The following is NOT an instruction error but an improvement to reinforce the engine cover. It requires using a standard #13/ #14 panel instead of the CaDa version of it, found in the set.

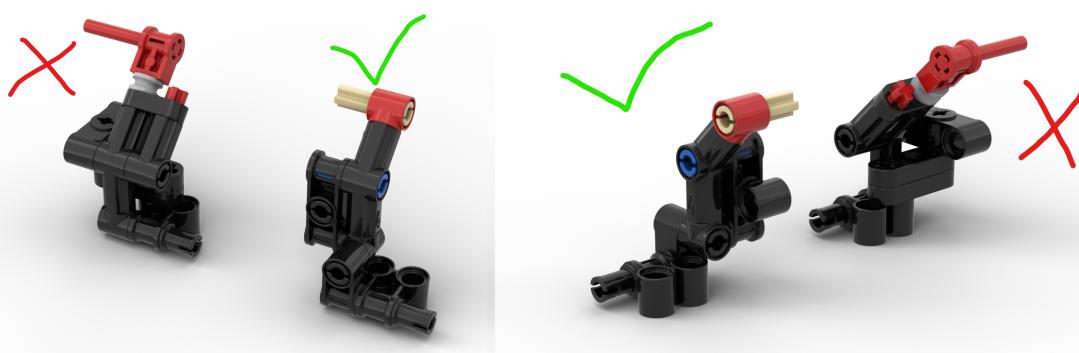
Use standard #3 / #4 panels (part number 64683)

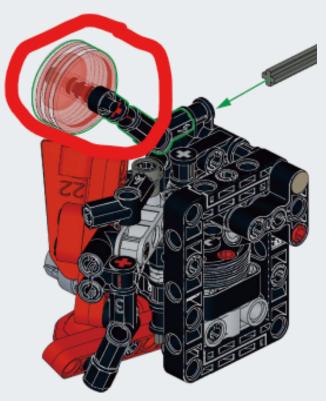
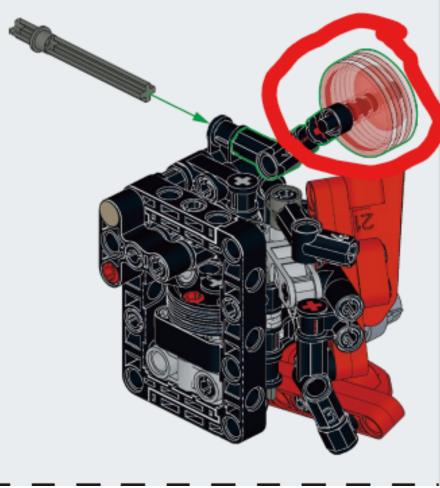
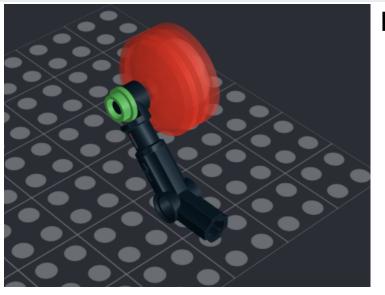
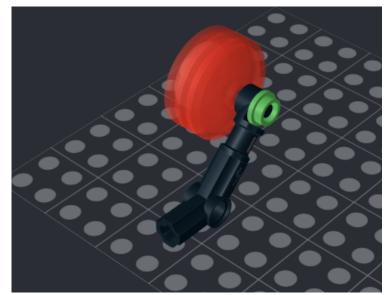
After completing the steps below, the wheelarch panel (part 69911) should now also be connected with its right pinhole, as indicated in the right bottom picture.
